Office Action Summary	Application No. 10/580,073	Applicant(s) MILKOWSKI ET AL.	
	Examiner ROBERT J. HICKS	Art Unit 3781

DETAILED ACTION

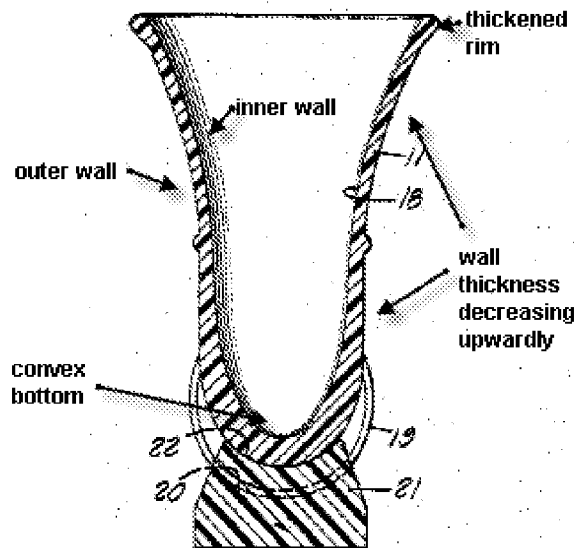
5. Claims 17 and 23 are rejected under 35 U.S.C. 102(b) as being anticipated by Bright (3,705,660).

Regarding Claim 17, the patent to Bright – a molded drinking container – discloses a preform of a plastic container [10, Fig. 3, Col. 2 Lines 3-8], comprising: a conically-shaped container [11] comprising a body having an inner wall and an outer wall defining a predetermined wall thickness [Fig. 3], said body having a bottom portion and a top portion, wherein the container body flares continuously outward from the bottom portion to the top portion [Fig. 3, Col. 2 Lines 23-27], wherein the degree in which the inner wall flares continuously outward is greater than the degree in which the outer wall flares continuously outward [Fig. 3], resulting in a wall thickness that gradually decreases starting from the bottom portion to the top portion [Fig. 3]; said bottom portion comprising a convex hemispherical shape; and said top portion comprising a cylindrical neck that includes a flange terminated in a thickened rim [Fig. 3].

Regarding Claim 23, Bright discloses the container body is plastic [Fig. 3, Col. 2 Lines 3-8]. See also MPEP § 608.02(IX) for the drawing cross-section for plastic.

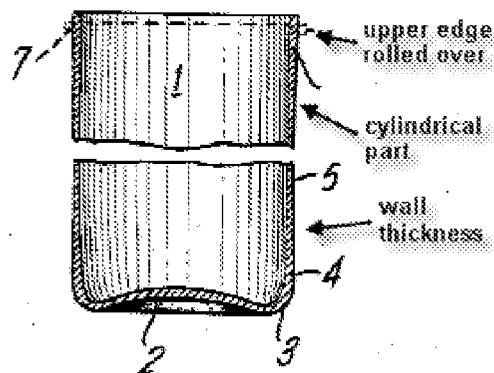
8. Claims 18 and 19 are rejected under 35 U.S.C. 103(a) as being unpatentable over Bright as applied to claim 17 above in view of Yoshikawa (3,785,311) and further in view of Britton (6,413,467).

Regarding Claim 18, Bright discloses all the limitations substantially as claimed, as applied to claim 17 above. Bright does not expressly disclose the features of claim 18; however, the patent to Yoshikawa - a container with a thickened upper rim – discloses a container with a flange [**Yoshikawa**, 7] having a flange end with a thickness less than 0.3 mm [**Yoshikawa**, Col. 4 Lines 18-25], and the wall thickness is less than or equal to the cylindrical wall thickness [**Yoshikawa**, Col. 3 Lines 60-65]. The flange is located at the top of the cylindrical wall, and can be dimensioned to the user's needs. It would have been obvious at the time of the invention to one of ordinary skill, with market forces or other incentives driving one of ordinary skill to modify the prior art, to manufacture the Bright container preform to have a rim with a thickness of less than 0.3 mm and to have the wall thickness less than or equal to the that of the cylindrical wall portion, as suggested by Yoshikawa, for “the other part than the upper edge of said can having an extremely thin thickness so as to curtail the amount of material to be used for the can” [**Yoshikawa**, Col. 2 Lines 22-25], and since it has been held that discovering an optimum value of a result effective variable involves only routine skill in the art. See *In re Boesch*, 617 F.2d 272, 205 USPQ 215 (CCPA 1980).

Although the Bright and Yoshikawa combination does not expressly disclose that the dimensioning of the thickness of the flange end and cylindrical wall is for plastics, the patent to Britton – a preform for a container – discloses that the preform used [Britton, 1] can be formed with a wall thickness and flange end thickness [Britton, 2, 6, and 7, Fig. 1] whether the preform is made of metal or plastic [Britton, Col. 3 Lines 7-12]. The method of forming the preform can be used with different materials. It would have been obvious at the time of the invention to one of ordinary skill, using the teaching, suggestion, and motivation within the prior art, to manufacture and dimension the flange end and the wall thickness of the Bright and Yoshikawa combination using plastic material, as suggested by Britton, to manufacture the preform easily [Britton, Col. 1 Lines 16-17 and 34-41].

Regarding Claim 19, Bright in view of Yoshikawa in view of Britton discloses all the limitations substantially as claimed, as applied to claim 18 above; further, Yoshikawa teaches the thickness of the flange is less than 0.3 mm [Yoshikawa, Col. 4 Lines 22-25].

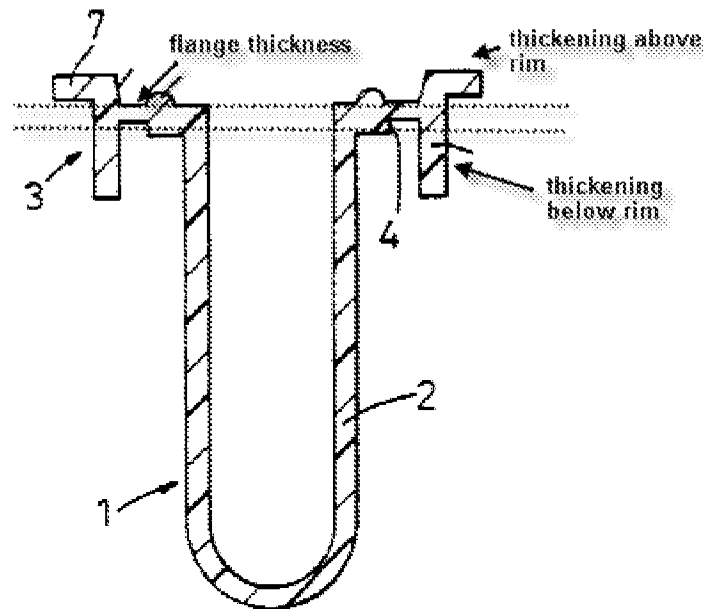
9. Claims 20-22 are 24 are rejected under 35 U.S.C. 103(a) as being unpatentable over Bright as applied to claim 17 above in view of Britton.

Regarding Claims 20-22, Bright discloses all the limitations substantially as claimed, as applied to claim 17 above. Bright does not expressly disclose the features of claims 20-22; however, the patent to Britton discloses a preform [**Britton**, 1] in which the rim [**Britton**, 3] has an annular thickening on top [**Britton**, 7], and underneath [**Britton**, 6] the rim, and in which the height of the thickenings range from 1.1 to 2.0 times the flange thickness [**Britton**, 4, Fig. 1]. The thicknesses on the top and bottom of the preform show rings that are attached to the flange, and which have heights that are more than the height of the flange. It would have been obvious at the time of the invention to one of ordinary skill, with market forces or other incentives driving one of ordinary skill to modify the prior art, to manufacture the thickening portions on the rim of the Bright preform to be larger than the flange thickness, as suggested by Britton, to be able to locate the container during manufacturing [**Britton**, Col. 1 Line 66 to Col. 2 Line 1], and since it has been held that discovering an optimum value of a result effective variable involves only routine skill in the art. See *In re Boesch*, 617 F.2d 272, 205 USPQ 215 (CCPA 1980).

Regarding Claim 24, Bright discloses all the limitations substantially as claimed, as applied to claim 17 above. Bright does not expressly disclose that the container is made from polyethylene terephthalate (PET); however, the patent to Britton discloses the preform [Britton, 1] is made from PET [Britton, Col. 3 Lines 7-12]. The preform can be made of various materials. It would have been obvious at the time of the invention to one of ordinary skill, using the teaching, suggestion, and motivation within the prior art, to manufacture the Bright container preform from PET, as suggested by Britton, to manufacture the preform easily [Britton, Col. 1 Lines 16-17 and 34-41].
